Memorandum

To: West Linn Planning Commission
From: Peter Spir, Associate Planner
Date: November 3, 2010
Re: Late submittals (CUP-10-03)

RECOMMENDED CONDITIONS OF APPROVAL (11-03-10)

WALKER MACY
 October 28, 2010
 1"=30'-0"

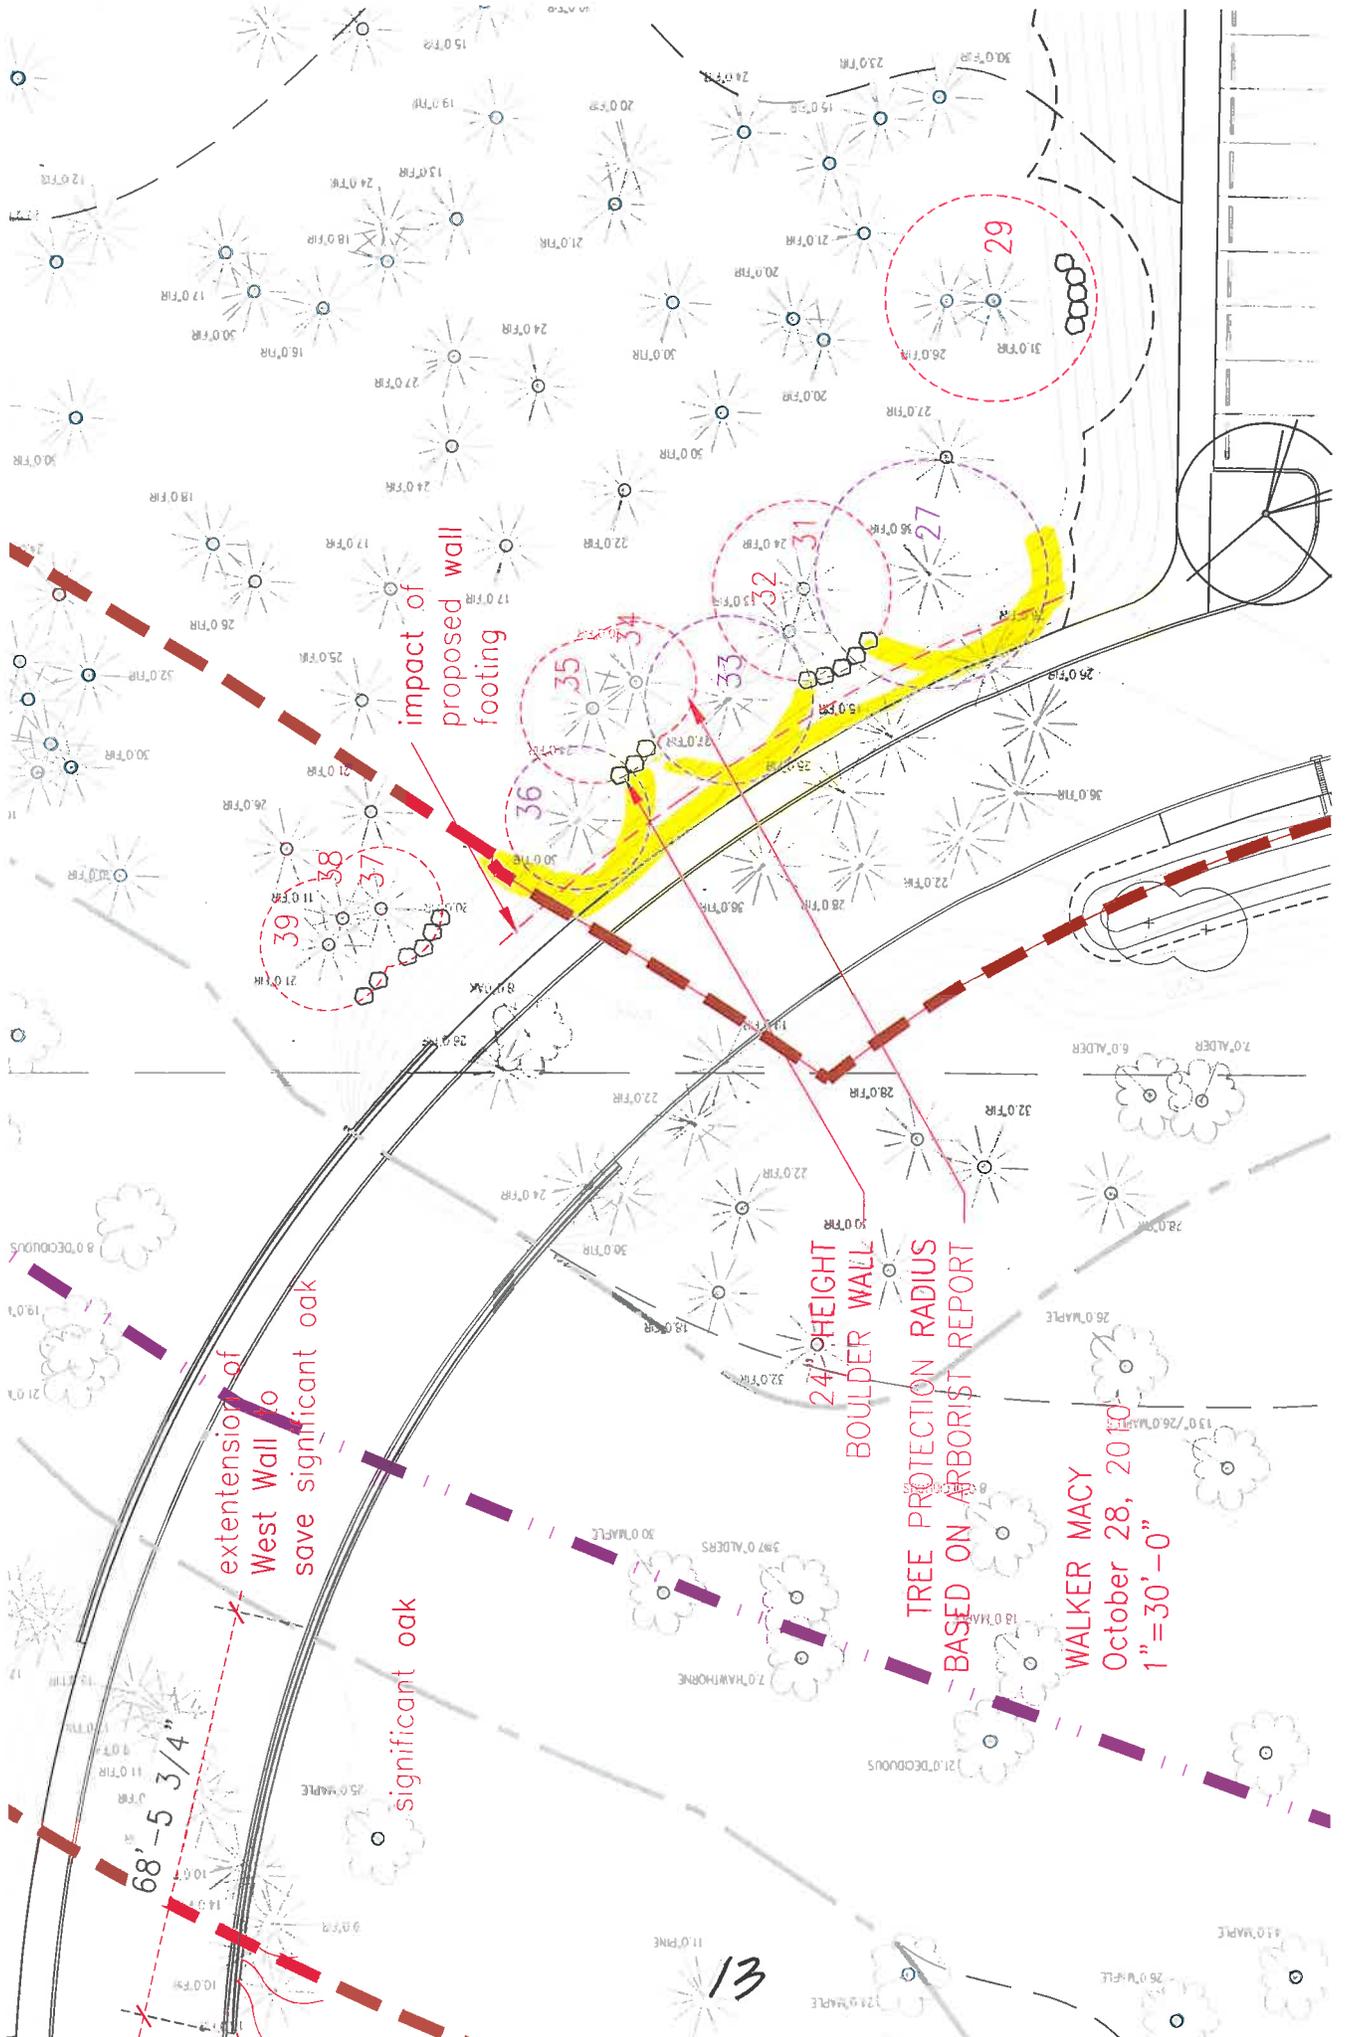
I believe that either scenario could work. I personally would rather see a little bit of fill encroach into the root zone than to see a large anchoring root get cut. However, it is highly possible with the retaining wall extension, that no large roots would be encountered.

It seems like a retaining wall that was tight to the edge of the sidewalk would be sufficient to protect all of the trees in question.

Please take a look at the attached sketch. It seems that trees 36, 33, and 27 would not benefit from the extension of the wall. Based on the tree protection radii we received from our team's arborist, these three trees will be impacted regardless. Additionally, the extension of the retaining wall will not add any additional tree protection value for the 7 other trees beyond what is provided by the low boulder wall.

I'd also like to make note that we have already voluntarily extended our retaining wall 70' on the west side of the creek crossing to avoid impacts to an Oregon White Oak, which is far more valuable than the 3 Douglas fir trees in questions.

impact of proposed wall footing

extension of West Wall to save significant oak

TREE PROTECTION RADIUS BASED ON ARBORIST REPORT
